UNITED STATES PATENT AND TRADEMARK OFFICE

APPLICATION NO.	FILING DATE	FIRST NAMED INVENTOR	ATTORNEY DOCKET NO.	CONFIRMATION NO.
10/690,828	10/23/2003	Ewen James Crawford Kellar	553-81	5416
23117	7590	10/05/2005	EXAMINER	
NIXON & VANDERHYE, PC 901 NORTH GLEBE ROAD, 11TH FLOOR ARLINGTON, VA 22203			IMAM, ALI M	
			ART UNIT	PAPER NUMBER
			3737

Office Action Summary	Application No.		Applicant(s)	
	10/690,828		CRAWFORD KELLAR ET AL.	
	Examiner		Art Unit	
	Ali Imam		3737

DETAILED ACTION

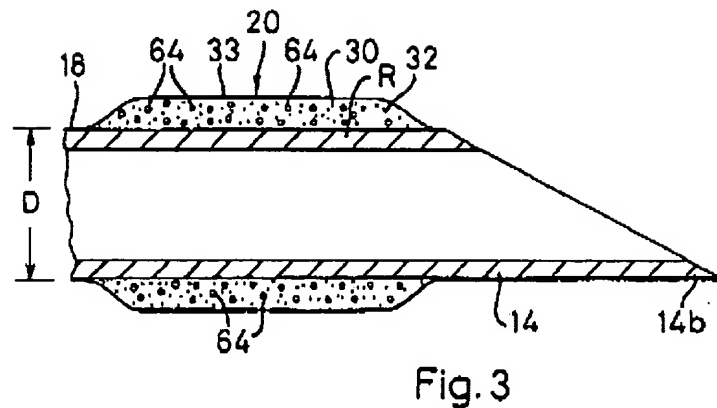
23. Claims 1, 3-7, 9-10, 17-22, 24, 26-29, 31-32, and 38-43 are rejected under 35 U.S.C. 103(a) as being unpatentable over Joseph (WO 98/18387 of record) in view of Violante et al. (US 6,106,473). Joseph discloses in page 9, line lines 1-28 and shows in Fig. 2 (reproduced below), an instrument (10) insertable into a medium and being capable of detection by sonic imaging equipment comprising an elongate member (14) for insertion into the medium and

having a region the position of which it is desirable to monitor, bubble generating means (effervescent material 32 of Fig. 3) for generating a plurality of discrete mobile gas bubbles at the region, whereby the bubbles are detectable by sonic imaging equipment wherein the bubble generating means comprises two elements, sodium hydrogen carbonate and citric powder, (col. 4, line7) which, upon contact with each other in the presence of fluid react with each other to produce the gas bubbles within a fluid (col. 3, lines 1-5). Joseph further teaches in Fig. 3 (reproduced below) a fluid permeable carrier material (30). Joseph teaches a single radially displaced layer (coating 20) containing both elements of the bubble generating means.

Joseph differs from the claimed invention because it does not explicitly disclose that the two elements of the bubble generating means comprise first and second radially displaced layers of the elements within the carrier material.

FIG. 1

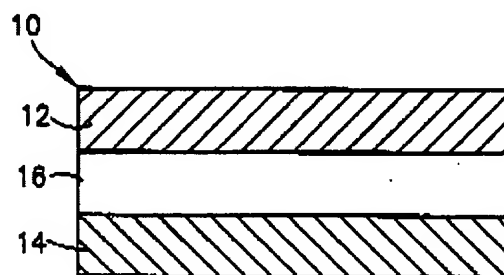
Carlin et al. (hereinafter "Carlin") teaches in Fig. 1 (reproduced below), an effervescent system containing three layers wherein the first, outer, layer (12) contains either the acidic element (e.g., the citric acid) or the basic element (e.g., the sodium hydrogen carbonate), the second, inner, layer (14) contains the other element that is not selected for the first layer (12), and the third, intermediate, layer (16) that is not chemically involved with the acidic or the basic

element (col. 3, lines 50-54). Carlin further discloses that the intermediate layer is used for separating the first and second layers containing the two elements for improving the handling of

the two elements (col. 3, line 6) and thereby minimizing reaction between layers prior to immersion in a liquid (col. 4, lines 30-32). The applicant may argue that the effervescent system of Carlin is from a different field of endeavor (dental cleanser). However, both Joseph's effervescent materials and Carlin's effervescent materials perform the same function that is to produce gas bubbles. Violante teaches in col. 8, lines 51-57, that gas bubbles are acoustically reflective in ultrasound applications and increases the visibility of a structure containing a coating that is capable of releasing the gas bubbles in a medium.
